**PLANNING COMMISSION  
SITE PLAN – COMPATIBILITY VARIANCES ONLY**

**CASE NUMBER:** SP-2021-0102C      **PC HEARING DATE:** April 26th, 2022

**PROJECT NAME:** 1400 Cedar Ave

**Re: Compatibility Setback Waiver**  
**1400 Cedar Ave (SP-2021-0102C)**  
1400 Cedar Ave, Austin, TX 78702

Revision Summary

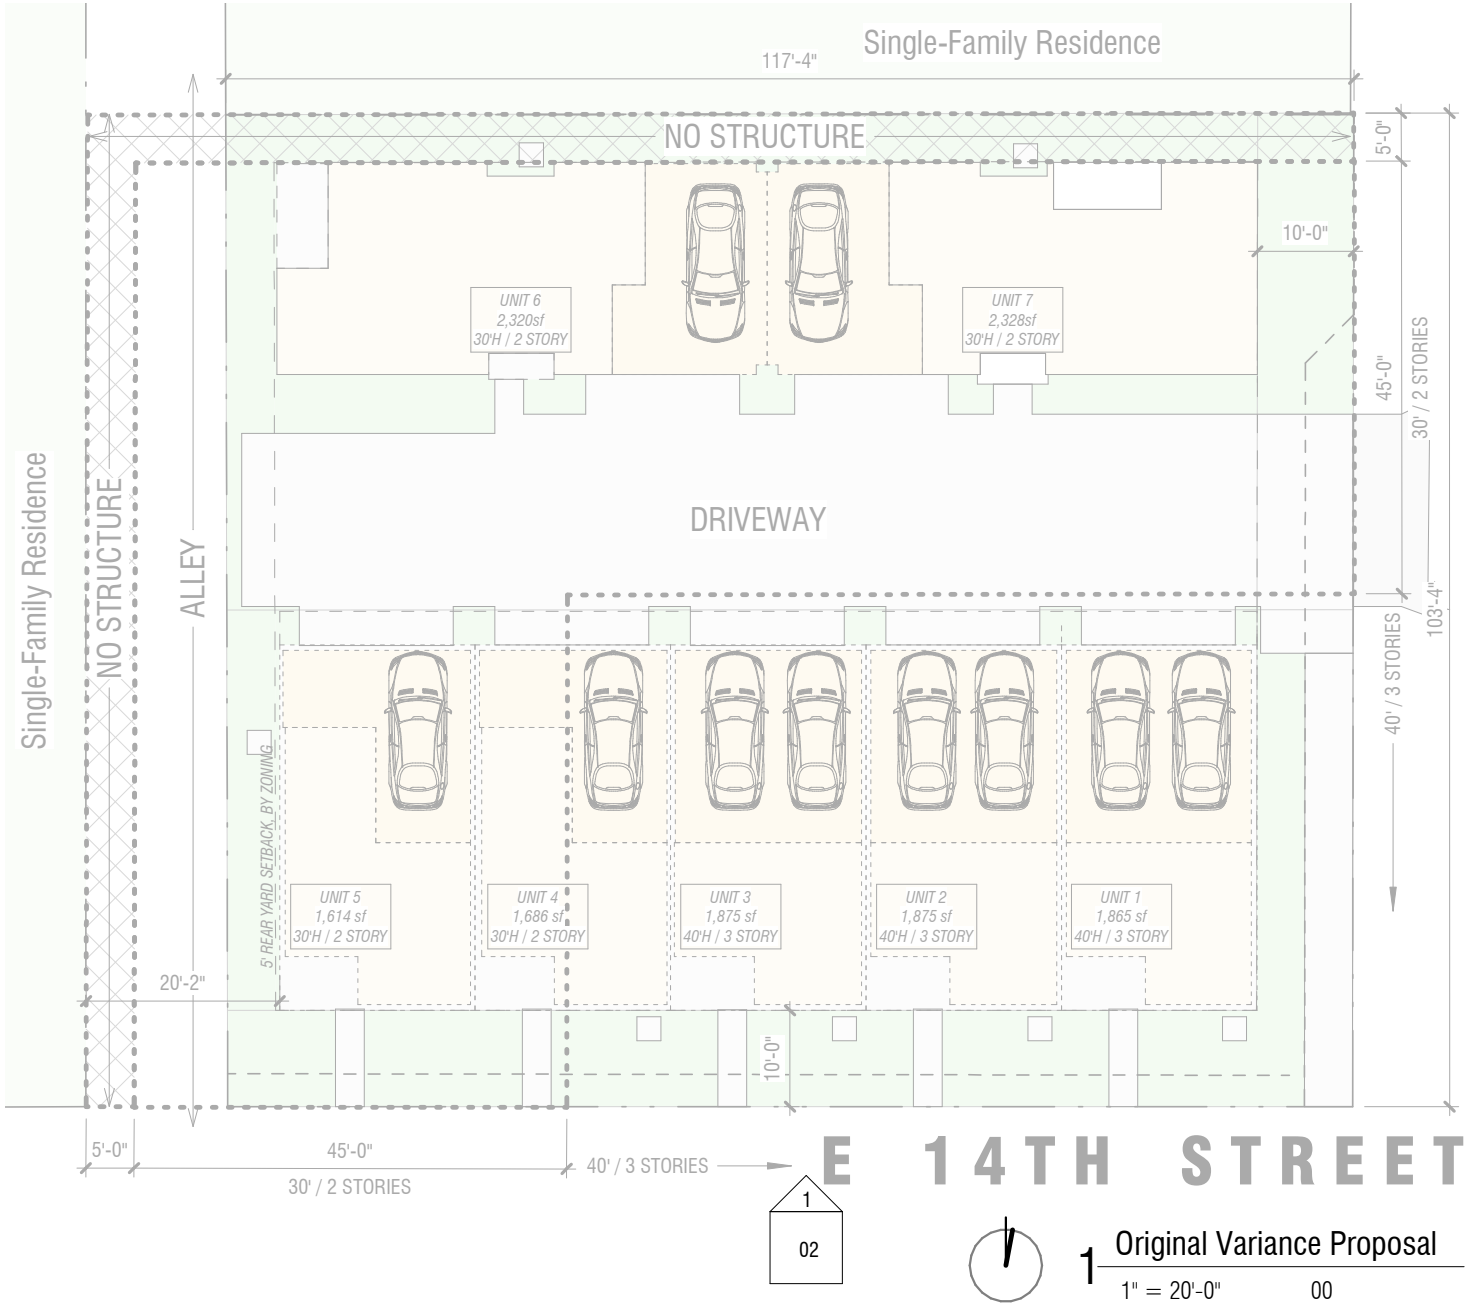
- ELIMINATE 2 UNITS (5 INSTEAD OF 7): REDUCE DENSITY, IMPERVIOUS COVER, AND TRAFFIC IMPACT
  - (EXISTING IMPERVIOUS @ 90-95%, 95% ALLOWED BY ZONING, 75%-80% ANTICIPATED)
- ADDED DISTANCE & IMPROVED SIGHTLINES FROM THE DRIVEWAY TO 14TH & CEDAR INTERSECTION
- INCREASED PARKING PER UNIT (2 EACH)
- 24' FRONT SETBACK WITH PRIVATE YARDS, IN KEEPING WITH NEIGHBORHOOD RESIDENTIAL CHARACTER
- NO VERTICAL STRUCTURE WITHIN 25' OF NORTH PROPERTY LINE (ON-GRADE IMPROVEMENT ONLY)
- 20' SETBACK FROM WEST NEIGHBOR ACROSS THE ALLEY
- 35' & 3 STORIES ALLOWED WITHIN THE BUILDABLE AREA

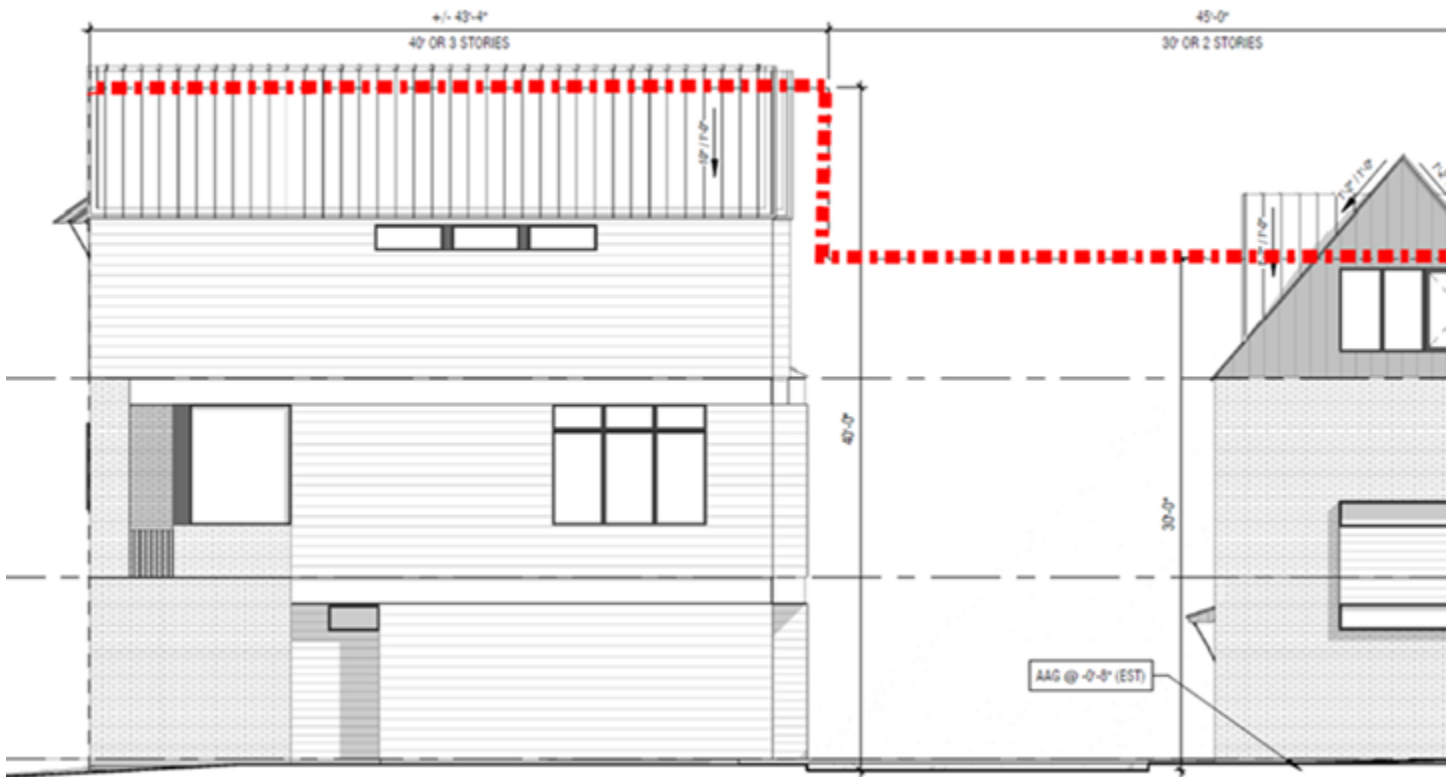
Hi Zack- Thanks for the explanation. As for the height, the exhibit seems to clearly show that they are exceeding the compatibility tent- see below. What am I missing? Thanks,

You are correct that this waiver is only for compatibility setbacks. The proposed development complies with the compatibility height regulations - this is shown in the background materials. I do realize that it's fairly nitty-gritty so let me know if you'd like to have a call to discuss it in more detail.
